ADA Curb Ramp New Construction Inspection Form (Perpendicular)

Nw 292nd

23885.56

Nw Fair

PERPENDICULAR RAMP (PR)

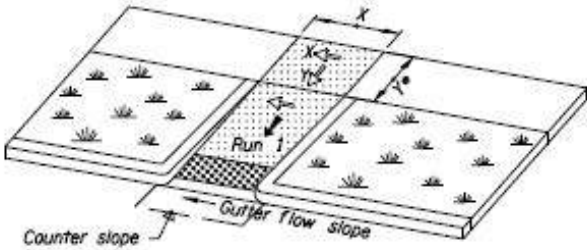
Pass	Fail
Running Slope 1	4.9	\leq 8.3%	<input checked="" type="checkbox"/>	<input type="checkbox"/>
Length 1	7.6			
Cross Slope 1	2.3	\leq 2.0%	<input type="checkbox"/>	<input checked="" type="checkbox"/>
Detectable Warning (Y,N)		Y	<input checked="" type="checkbox"/>	<input type="checkbox"/>
Lip Height		1/4"	<input checked="" type="checkbox"/>	<input type="checkbox"/>
Gutter Flow Slope	1.3	\leq *	<input checked="" type="checkbox"/>	<input type="checkbox"/>
Curb Running Slope (avg)	3.98	\leq 8.3%	<input checked="" type="checkbox"/>	<input type="checkbox"/>
Counter Slope (+/-) *2	4.1	\leq 5.0%	<input checked="" type="checkbox"/>	<input type="checkbox"/>

Width X	7.4	\geq 4.0'	<input checked="" type="checkbox"/>	<input type="checkbox"/>
Length Y	5.75	\geq 4.0'*1	<input checked="" type="checkbox"/>	<input type="checkbox"/>
Back of Ramp Obstruction (Y/N)		\geq 5.0'*1	<input checked="" type="checkbox"/>	<input type="checkbox"/>
Slope X	2.9	\leq 2.0%	<input type="checkbox"/>	<input checked="" type="checkbox"/>
Slope Y		\leq 2.0%	<input checked="" type="checkbox"/>	<input type="checkbox"/>

Tool joints in TS
